PCN# 20221031004.1
Qualification of new Fab site (RFAB) using qualified Process Technology, Die Revision, Datasheet update and additional Assembly site options for select devices
Change Notification / Sample Request

PCN Number:	20221031004.1	PCN Date:	November 01, 2022
Title:	Qualification of new Fab site (RFAB) using qualified Process Technology, Die Revision, Datasheet update and additional Assembly site options for select devices		
Customer Contact:	PCN Manager	Dept:	Quality Services
Proposed 1st Ship Date:	Jan 31, 2023	Sample requests accepted until:	Nov 30, 2022*

Sample product shipping label (not actual product label)

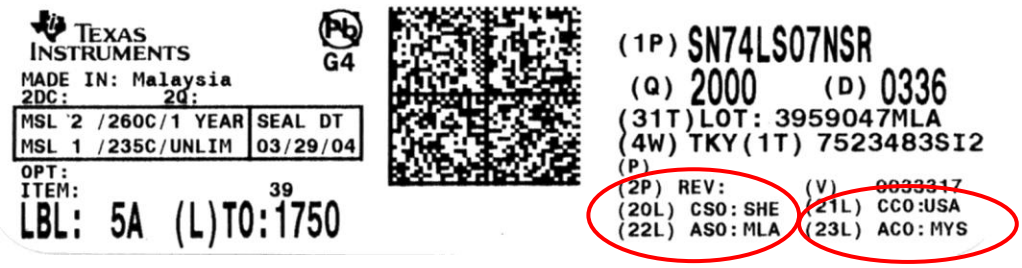
Changes to product identification resulting from this PCN:

Chip Site	Chip Site Origin Code (20L)	Chip Site Country Code (21L)	Chip Site City
DL-LIN	DLN	USA	Dallas
SH-BIP-1	SHE	USA	Sherman
RFAB	**RFB**	**USA**	**Richardson**

Current	New
Die Rev [2P]	**Die Rev [2P]**
A, B, F	**-**

Assembly Site	Assembly Site Origin (22L)	Assembly Country Code (23L)	Assembly City
FMX	MEX	MEX	Aguascalientes
CARZ	CSZ	CHN	Jiangsu
CRS	CRS	MYS	Jelapang, Ipoh
MLA	**MLA**	**MYS**	**KUALA LUMPUR**
CDAT	**CDA**	**CHN**	**Chengdu**
